Access Compliance Report

Public Rights-of-Way

(Curb Ramps)

Intersection ID: 52622	Main Street: HERITAGE_POND_DR	Cross Street: ALEXANDER_COMMONS_DR	Location: S
ADA ID: B573B90D589E	Ramp Type: Perp	Initial Pass/Fail: Fail	Overall Compliance: No
Severity Score: 25			
Codes/Mitigation Info/Possible Solution		Field Measurements/Component Compliance

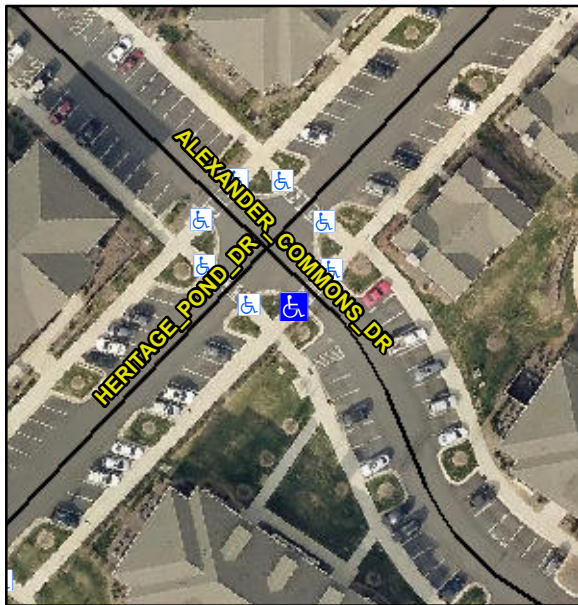
PROW/ADA:

R304.2.2

Compliance	Description	Data	Compliance	Description	Data
N/A	Ramp Length (in)	94.0	No	Ramp Slope (%)	14.2
Yes	Ramp Width (in)	92.5	Yes	Ramp XSlope (%)	0.4
N/A	Flare Type LT	N/A	N/A	Flare Type RT	N/A
N/A	Flare Slope LT (%)	N/A	N/A	Flare Slope RT (%)	N/A
N/A	Flare Traversable LT?	N/A	N/A	Flare Traversable RT?	N/A
N/A	Landing Length (in)	N/A	N/A	DWS Provided?	N/A
N/A	Landing Width (in)	N/A	N/A	DWS Contrast?	N/A
N/A	Landing Slope (%)	N/A	N/A	DWS Length (in)	N/A
N/A	Landing X Slope (%)	N/A	N/A	DWS Full Width?	N/A
N/A	Landing Curb? (Y/N)	N/A	N/A	DWS Offset (in)	N/A
N/A	Shared Landing?	N/A			
N/A	Gutter Ponding?	N/A	N/A	Gutter Slope (%)	N/A
N/A	Gutter Lip Ht (in)	N/A	N/A	Gutter X Slope (%)	N/A
N/A	Painted X Walk1?	Yes	N/A	Painted X Walk2?	N/A
	X Walk 1 Direction	To NE		X Walk 2 Direction	N/A
N/A	X Walk 1 Width (in)	91.5	N/A	X Walk 2 Width (in)	N/A
	X Walk 1 Slope (%)	0.2		X Walk 2 Slope (%)	N/A
	X Walk 1 X Slope (%)	1.5		X Walk 2 X Slope (%)	N/A

Remove & Replace Entire Ramp.
